LOT GRADING REVIEW

LECCO RIDGE DEVELOPMENTS INC.

PROJ. No. 16-12 MUNICIPAL ADDRESS

LOT No. 71

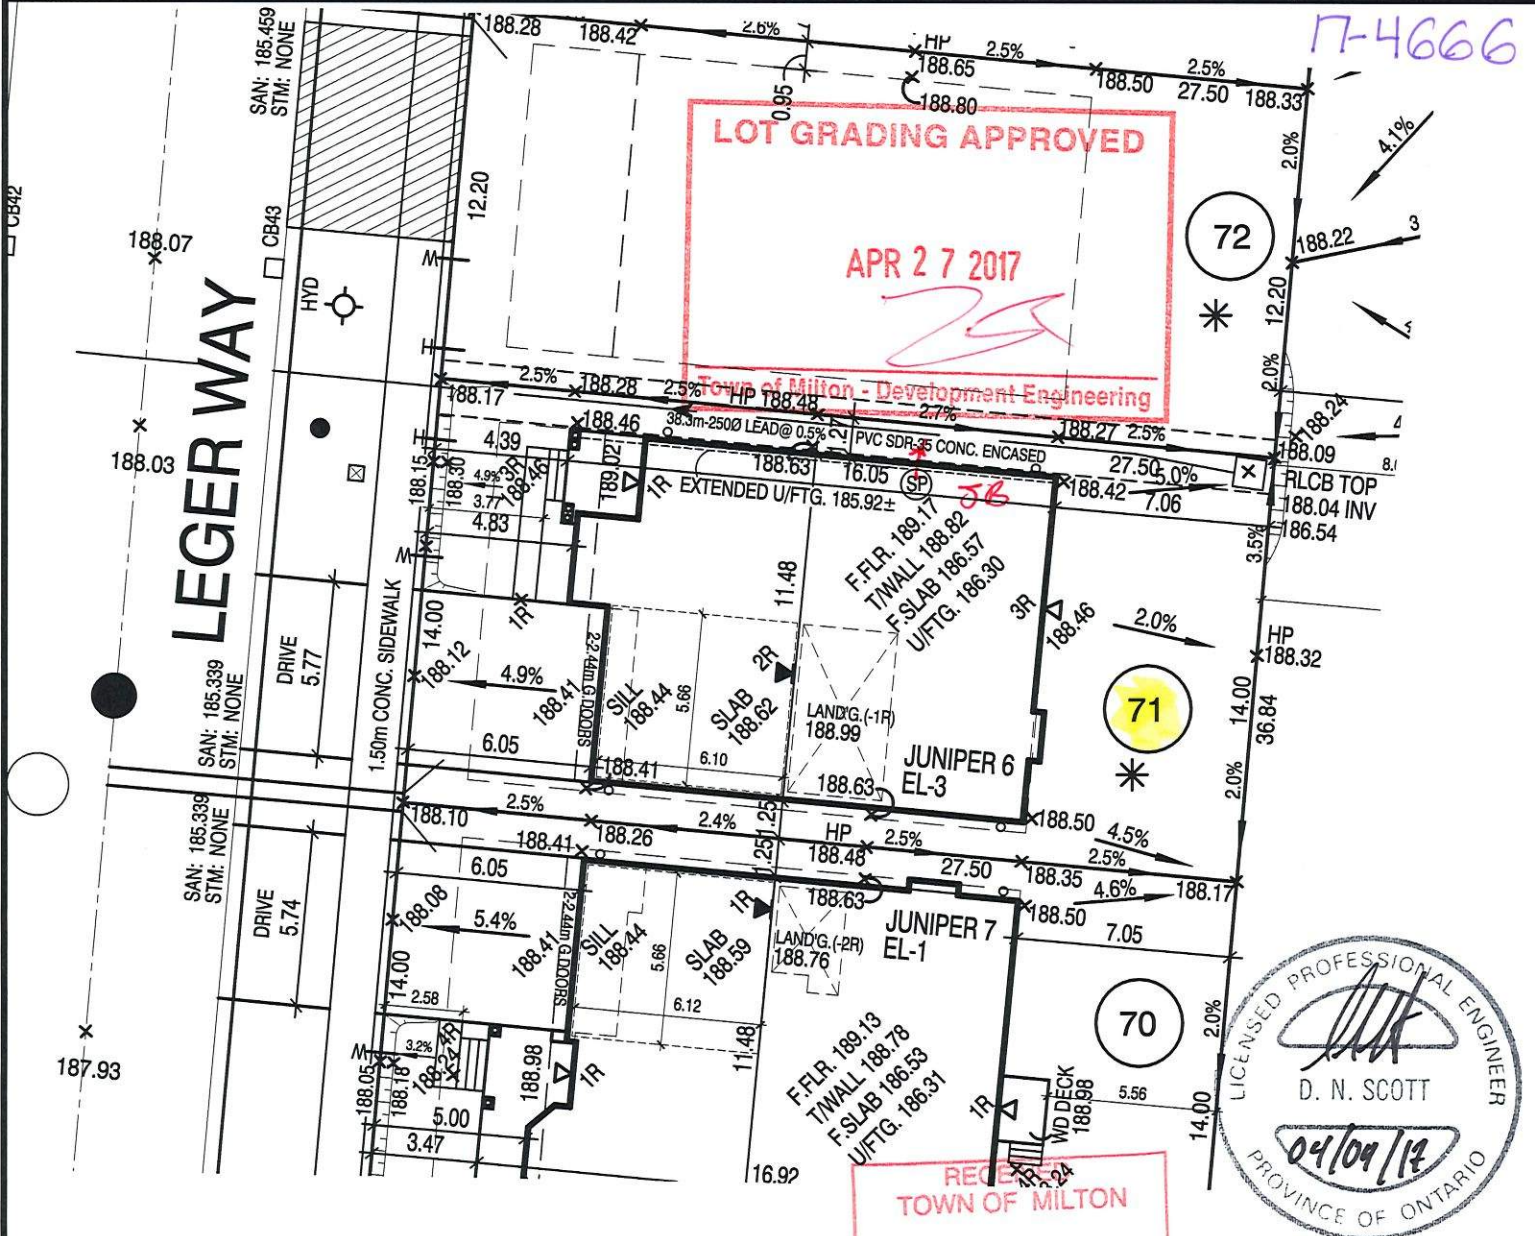
45 Min FRR

45 Min FRR w/NC Cladding

Guard/Handrail as per 9.8.

2.06 m Backfill height as per 9.15.

Siting to be read in conjunction with reviewed main model drawings

SUMP PUMP TO DISCHARGE TO REAR SPLASH PAD.

45 MINUTE RATED WALL

WITH SIDE YARD < 1.2m
